State of California – Natural Resources Agency DEPARTMENT OF FISH AND WILDLIFE Central Region 1234 East Shaw Avenue Fresno, California 93710 (559) 243-4005 www.wildlife.ca.gov

Subject: Harper Canyon (Encina Hills) Subdivision Project (Project)

**Supplemental Draft Environmental Impact Report (SDEIR)**

SCH No.: 2003071157

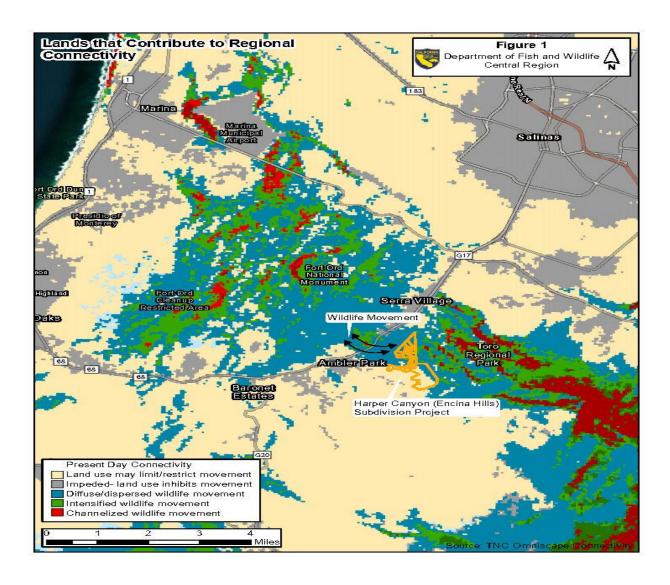
The Project's 17-lot residential subdivision would almost entirely block a primary wildlife corridor between Fort Ord and Toro Park and further isolate Fort Ord and the wildlife species that inhabit the monument (Attachment 1, Figure 1). Attachment 1, Figures 1 and 2, utilize The Nature Conservancy (TNC) Omniscape Connectivity Web Map (TNC 2024) dataset to model wildlife movement within and surrounding the Project site. As Attachment 1, Figures 1 and 2, depict, the majority of the residential subdivision is directly within the sole migratory pathway between Fort Ord and Toro Park. While the SDEIR recognizes the potential impacts to wildlife connectivity associated with the siting of the Project site, and specifically provides mitigation measures to protect a portion of the El Toro Creek corridor, CDFW is concerned that without the protection of the surrounding movement pathways identified in Attachment 1, Figures 1 and 2, the Project would not adequately mitigate for the impacts to wildlife movement.

Based on the information provided in Attachment 1, Figures 1 and 2, the CCCP, and the DEIR and SDEIR, CDFW is concerned that if the Project were to be implemented as currently proposed, and with the mitigation measures currently proposed, there is a strong likelihood that the linkage to Fort Ord would be severely constricted or lost entirely, especially for species that are less mobile or have large home ranges. Essentially, CDFW is concerned the proposed Project would likely lead to further fragmentation of already constrained habitat for a multitude of species.

As the proposed Project is likely to significantly restrict wildlife movement between Fort Ord and Toro Park, CDFW recommends the SDEIR be revised and that the Project site be redesigned to allow for a minimum 1.2-mile-wide corridor through the movement areas identified in Attachment 1, Figures 1 and 2 that are within the Project site, to maintain the linkage between Fort Ord and Toro Park. This corridor width recommendation follows the recommendations noted in the South Coast Missing Linkages Project (Penrod et al., 2006), a project focused on finding missing linkages, or corridors, in southern California, which notes that a minimum 1.2 miles width allows, "For a variety of species [...] a wide linkage helps ensure availability of appropriate habitat, host plants (e.g., for butterflies), pollinators, and areas with low predation risk.
